24210-01-001

ROSSLARE EUROPORT ORE HUB ACCESS ROAD

Road Safety Audit Stage 1

Location: Roundabout Junction

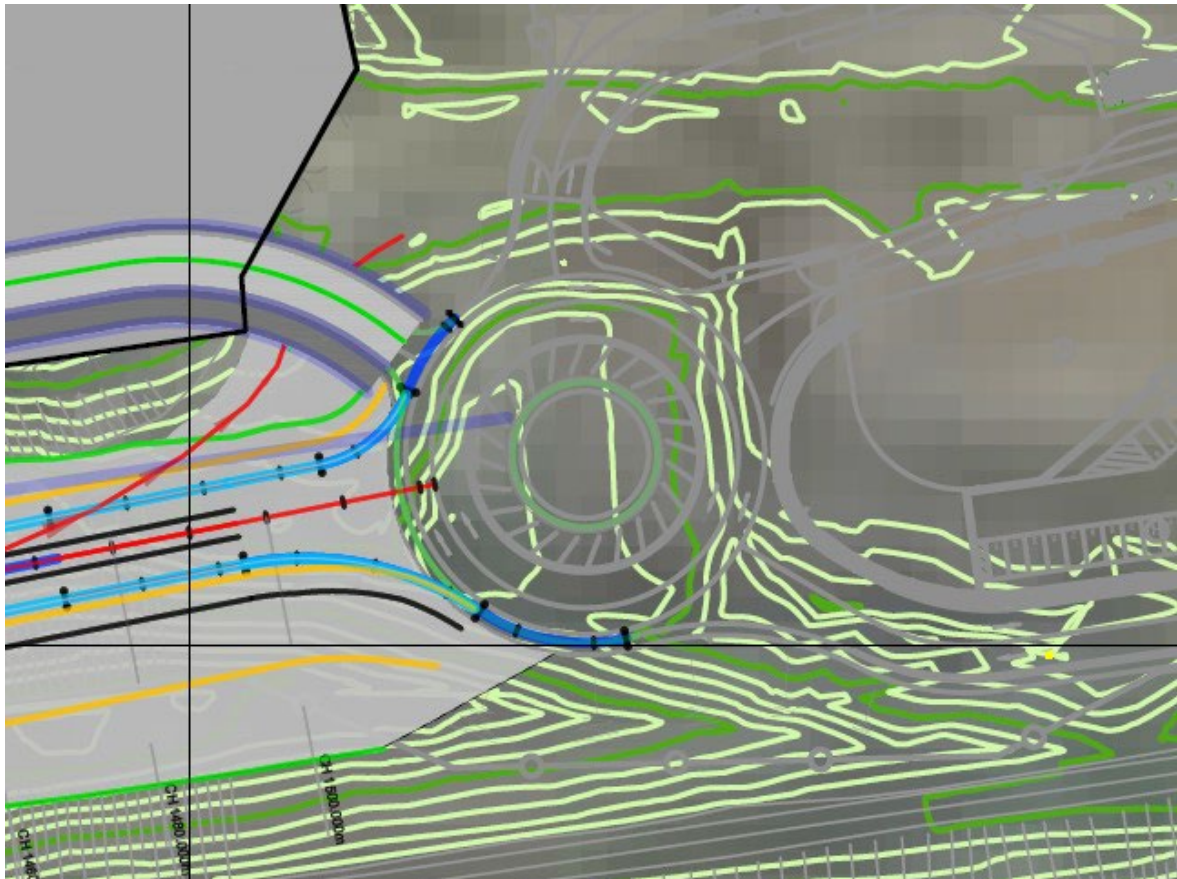
2.1 **Problem:** Entry/Exit

Drivers of vehicles approaching the roundabout from the Rosslare Europort access road wishing to exit onto the access road to the small craft harbour will be unable to safely negotiate the manoeuvre owing to the proximity of the entry to the exit. This may lead to sudden braking leading to rear end collisions.

Erect signs on the Rosslare Europort access road approach to inform drivers, especially those in large vehicles, who wish to access the small craft harbour to travel around the roundabout circulatory carriageway.

Location: Roundabout Junction

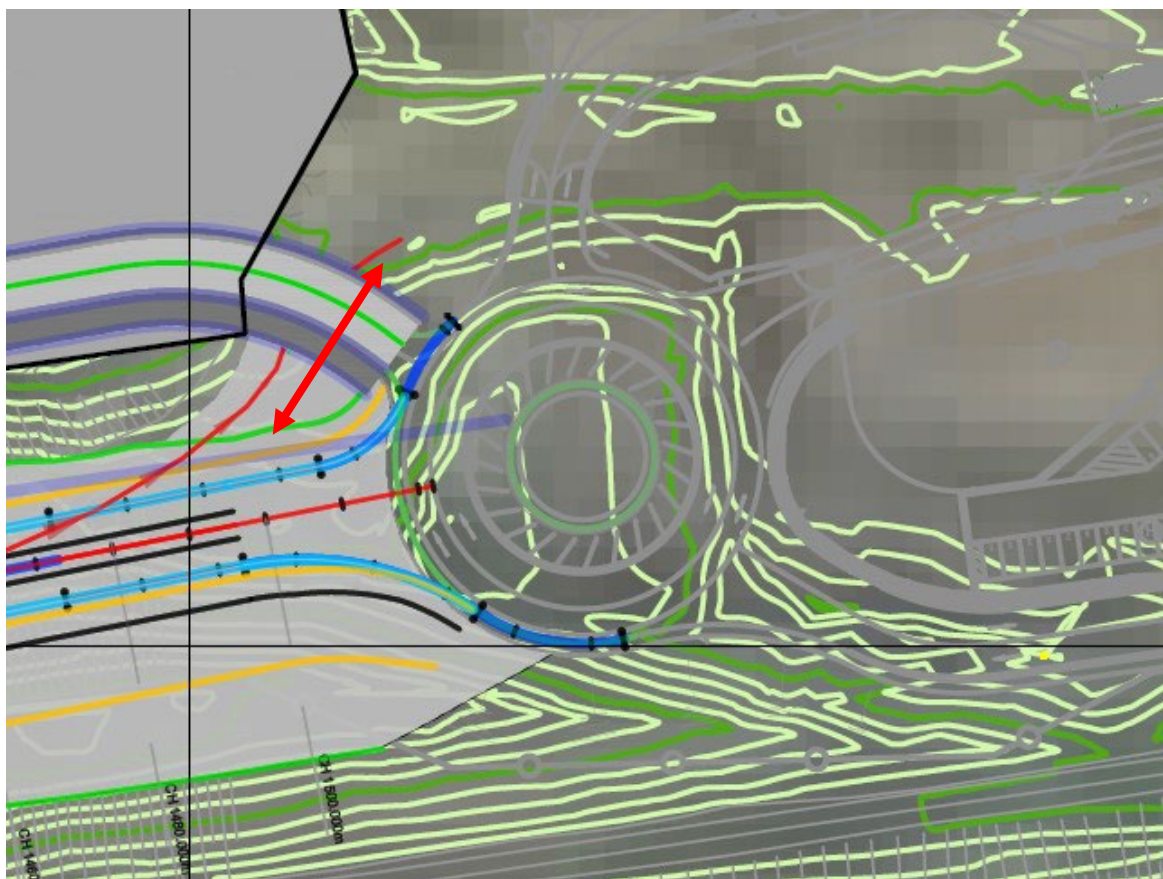
2.2 **Problem:** Intervisibility

Drivers of vehicles exiting from the small craft harbour road may not be aware of vehicles, likely to be HGV/Freight traffic, heading towards the port, entering onto the circulatory carriageway from the adjacent Rosslare Europort access road. This may lead to side impact collisions if they enter into the path of approaching vehicles on the circulatory carriageway.

Ensure that drivers on the small craft harbour road have clear visibility to vehicles entering from the Rosslare Europort access road.
